**RECALL CAMPAIGN
INSTRUCTIONS**

REF. NO. C24100080

**REPLACEMENT OF BRAKE FLUID
RESERVOIR CAP**

MODEL YEARS 2013 - 2017

New Adhesive Sticker

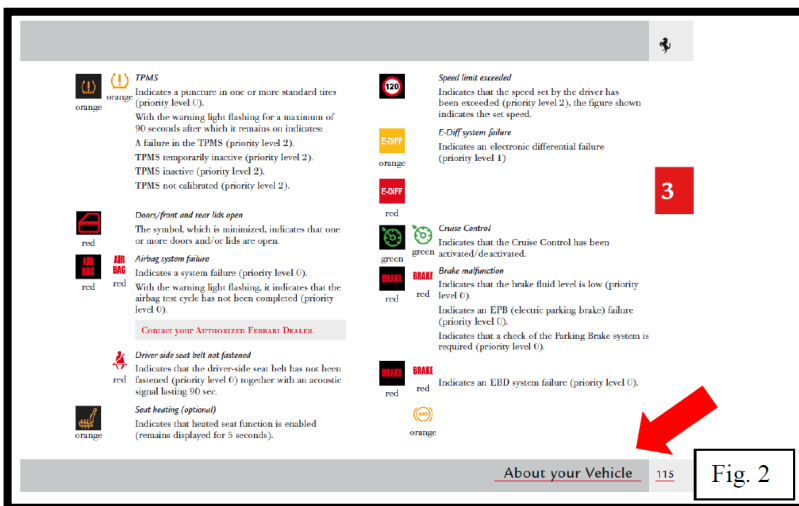
Please find below the proper location and instructions on how to insert the provided sticker into the Owner's Manual (PN: 079641778)

The sticker must be placed on the page shown above in the Owner's Manual. This page is located in the **"About Your Vehicle"** section where the warning lights on the instrument panel are described. Please be sure to attach it to the page with the **"Low Brake Fluid"** description as shown above in Fig. 2.

Once you locate the proper page, remove the adhesive protector off of the back of the sticker. Ensure there is no residue or other particles on the page that may inhibit the longevity of adhesion to the page. Place the sticker to allow the bottom of the sticker to lay directly above the gray margin at the bottom of the page that contains the text **"About your Vehicle"**.
